# Planning Report

## Riviera

Agenda Item	1
Case Number	14-068Z/PDP/PP
Site Location	8205 Avery Road West side of Avery Road, north of the intersection with Belvedere Green Boulevard
Proposal:	A rezoning of approximately 152.2 acres from R, Rural District and R-1, Restricted Suburban Residential District to PUD, Planned Unit Development District for the potential development of the site with up to 185 single-family lots and approximately 76 acres of open space.
Requests	Review and recommendation to City Council of a <u>rezoning with preliminary development plan</u> under the Planned District provisions of Zoning Code Section 153.050, and a <u>preliminary plat</u> under the provisions of the Subdivision Regulations, Chapter 152.
Applicant:	Charles Ruma; represented by Smith and Hale.
Planning Contact:	Claudia D. Husak, AICP, Planner II   (614) 410-4675, <a href="mailto:chusak@dublin.oh.us">chusak@dublin.oh.us</a>
Planning Recommendation:	<b><i>Approval of the rezoning with preliminary development plan with four conditions; and Approval of the preliminary plat with one condition.</i></b>

**Traffic and Access**

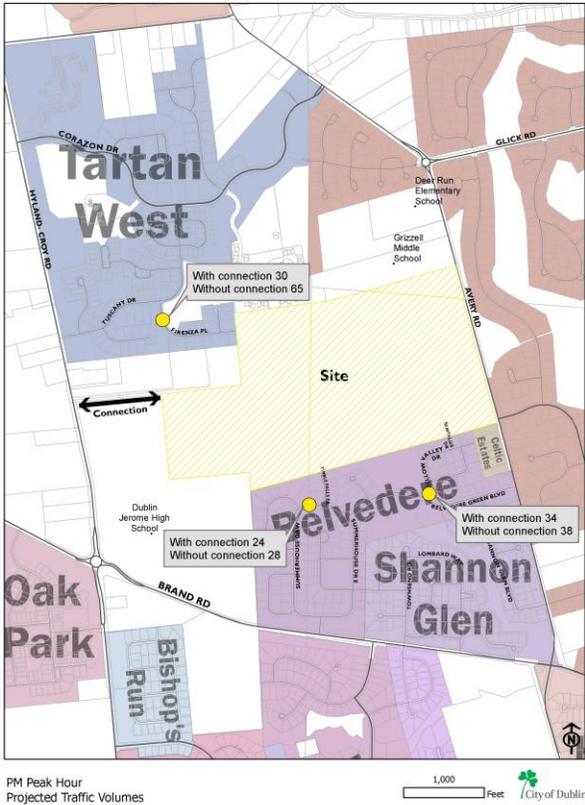
All proposed streets are public and the names have been approved by the City. The main access point, Riviera Boulevard will provide site access from Avery Road and ends at Devito Way adjacent to the central park. Devito Way provides north and south access to Subareas A and B. Several streets loop through the development to provide access to smaller pods of homes.

Street connections to existing stubs in surrounding developments include Firenza Place to the northwest, and Timble Falls and Tantalus Drives to the south. A street stub (Cacchio Place) is provided at the west edge of the site to allow for a future connection to Hyland-Croy Road. Planning requests the applicant include with the final development plan that a sign be posted at the stub street indicating the future planned connection for this section.

Planning and Engineering will require the connection to Hyland Croy Road be made prior to the approval of a final plat that includes the connection of Firenza Place in Tartan West.
